STAFF'S
REQUEST ANALYSIS
AND
RECOMMENDATION

04PR0391

Smith Packett Med-Com, Inc
(The Crossings at Bon Air)

REQUEST: Site plan approval of an adjustment to a site plan previously approved through administrative review.

THE CROSSINGS AT BON AIR
LAYOUT PLAN (PHASE II)
MIDDLEBURGH DISTRICT
CHESTERFIELD COUNTY, VIRGINIA

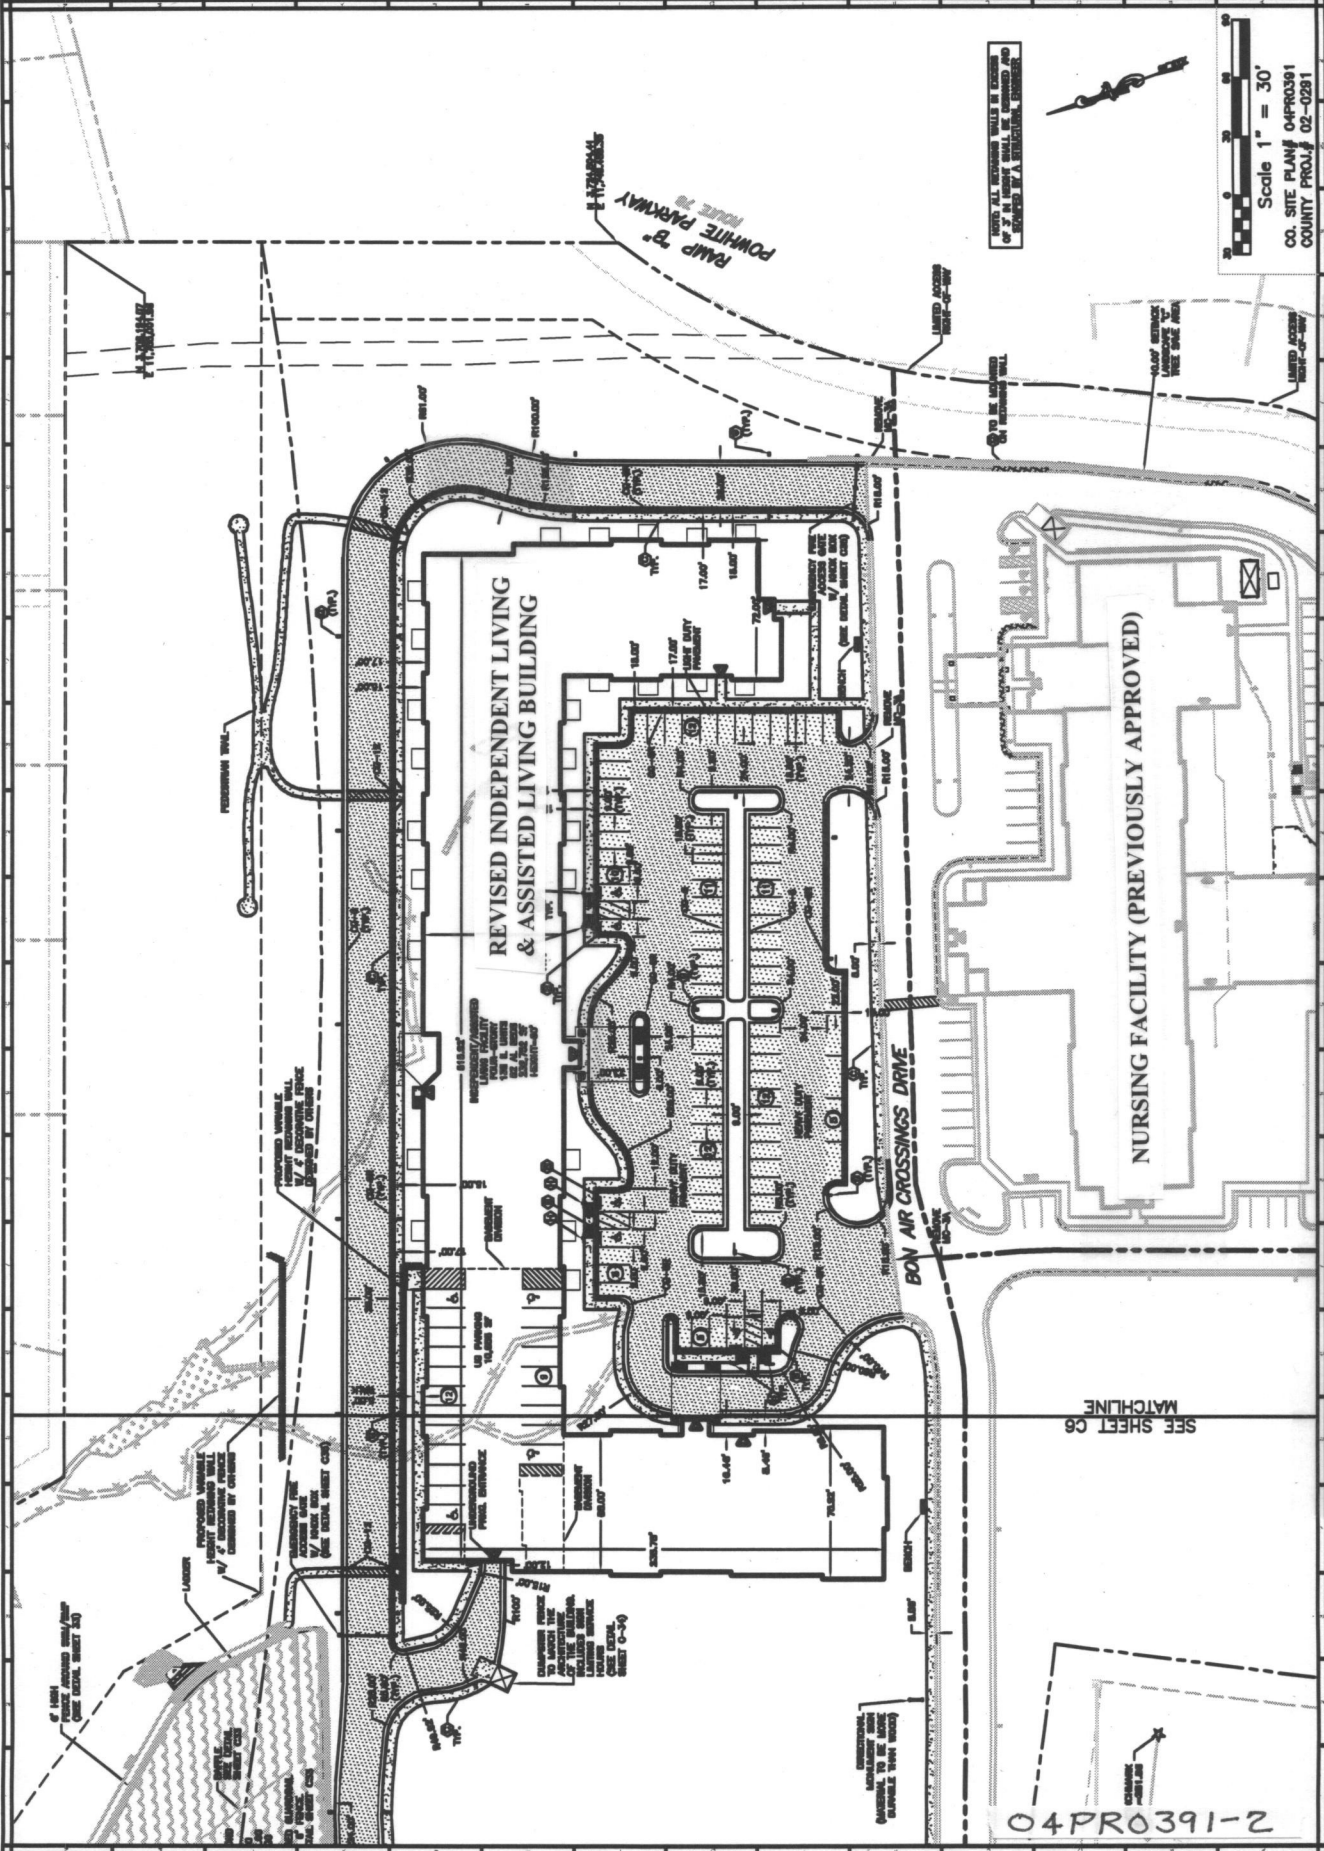
**PROPOSED 40 FT WIDE ENTRANCE
(PREVIOUSLY APPROVED AS A 24FT WIDE
GATED EMERGENCY ENTRANCE)**

REVISED INDEPENDENT LIVING & ASSISTED LIVING BUILDING
(SIZE REDUCED WITH MINOR CHANGES TO PARKING LAYOUT)

1. VDOT cannot support this proposed increased usage of the Route 60 entrance, due to operational and safety concerns raised by the proximity of the access to the Powhite Parkway off-ramp and to the signalized intersection of Route 60 and Pinetta Road. The original intent in allowing the site to connect to the driveway was to provide only emergency service to the site to reduce these problems. (VDOT)

2. The change in use of the entrance and the increase in traffic at the entrance introduce the need to meet minimum VDOT standards, which are not currently met. The separation between entrance and intersection is less than the required length of 400 feet, to allow full right turn lane to the intersection. The site's projected traffic may also create the need for a separate right turn lane into the Route 60 site entrance. (VDOT)

9. The access to Route 60 must be gated to permit emergency vehicles only. (T)
10. Gate detail is shown on plan, however the placement location of the gate needs to be marked on plan. (F)

12. The independent living/assisted living building requires only 1 meter. Revise the plans to show only 1 1.5" meter for the building. (U)

18. Revise the plans so that the entrance and drive to the below grade parking is at least 22 feet wide per Sec. 19-514(b)(2). (P)
